DOOSAN Document Transmittal Upper Trishuli-1 HEP (216MW)	Date 2022-03-06	DT No.: UT1-HEP-DHI-PC-D-0010	SHEET 1 OF 1
DOOSAN NEPAL BRANCH OFFICE	Address & Contact No. : Four Square Building, Naxal, Kathmandu, Nepal (P.O Box : 1387) + 977 1 692 3014	Project No. H20002	DOCUMENT DISPATCHED BY Courier Service ☐ Messenger ☐ Post-Air Freight ☐ Document System or E-mail ■ By hand ■
DOCUMENT DISTRIBUTION	■ POWER CHINA (Subcontractor) ☐ Doosan's Site Office		
SUBJECT	Review Note RN-0076_Layout of Access Tunnel to Powerhouse

UPPER TRISHULI-1 HEP (216MW)

REVIEW NOTE

Contractor	**Doosan Heavy Industries & Construction Co., Ltd.**		
Title of the Document	Layout of access tunnel to Powerhouse, sheets 1-2		
Document No.	UT1-C-090-CVL-DG-64001	Revision	0A
Date of Documents	28.07.2021	Received Date	19.08.2021
Transmittal Form No.	UT1-HEP-DHI-D-0034		
Previous Review Date/Status	N/A	Prev. Review Note No.	N/A
Review Note No.	**RN-0076**	**Present Review Date**	**06.03.2022**
		Present Review Status	**FI**

PLAN LAYOUT OF ACCESS TUNNEL

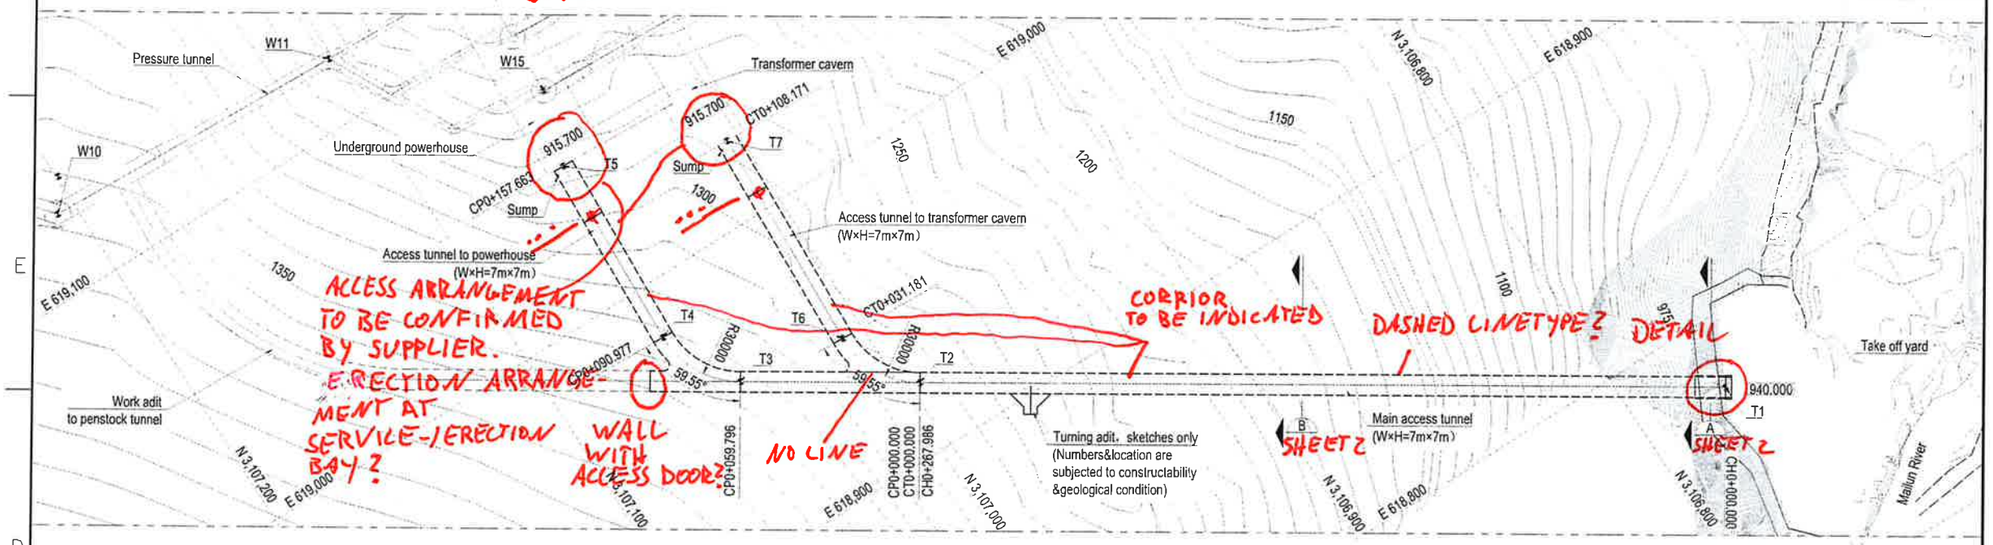
KEY PLAN MAYBE ONLY POWER HOUSE AREA

ALREADY IN TITLE BLOCK

=> DOCUMENT IS CONSIDERED FOR INFORMATION

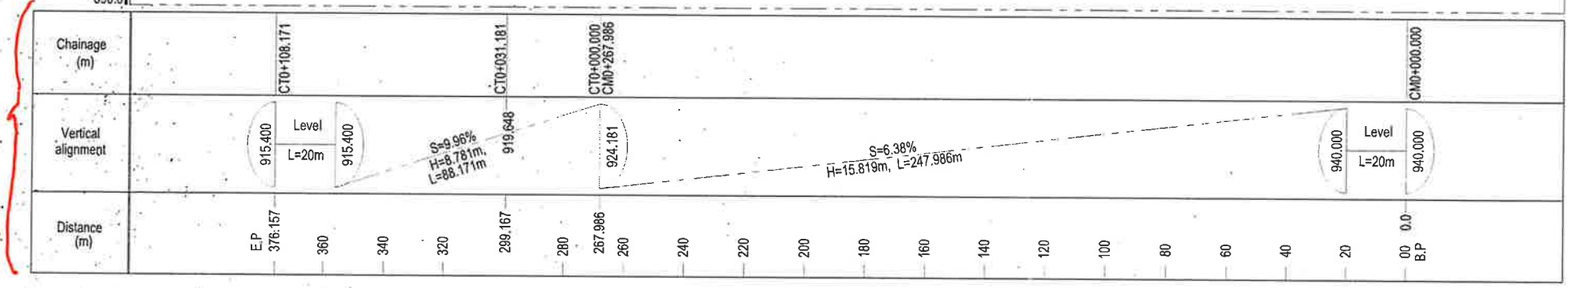
SEE AS EXAMPLE SUBMITTED PROTOTYPE DG.

SECTION A-A
1:100

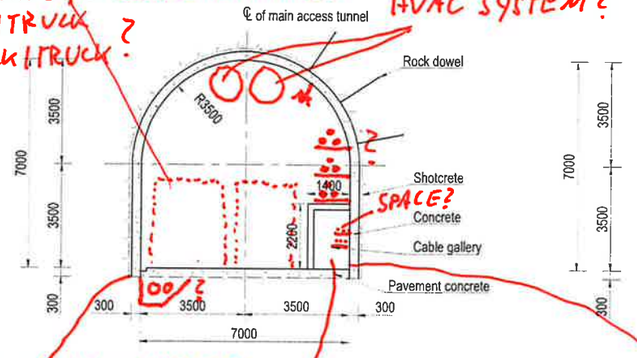
CLEARANCE PROFILE OF DECISIVE VEHICLE (1-LANE / 2-LANE TRAFFIC?)
- CAR/TRUCK
- TRUCK/TRUCK ?

PERMANENT HVAC SYSTEM?

OTHER SUPPLY CHANNELS?
- WATER / WASTE WATER
- LOW VOLTAGE / MEDIUM V.
- COMMUNICATION / SIGNALIZATION
- ...

EMERGENCY ESCAPE CORRIDOR? ↳ NOT IN COMBINATION WITH HIGH VOLTAGE CABLES

SECTION B-B
1:100

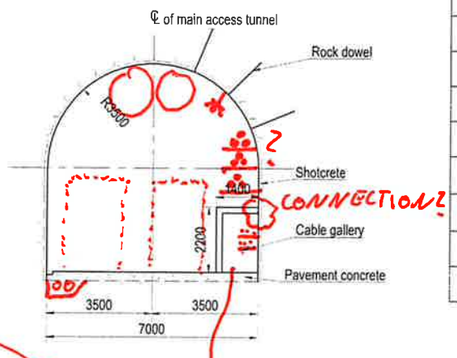
SEE COMMENTS SECTION A-A

CORRIDOR TO BE INDICATED IN PLAN / LONG. PROFILES
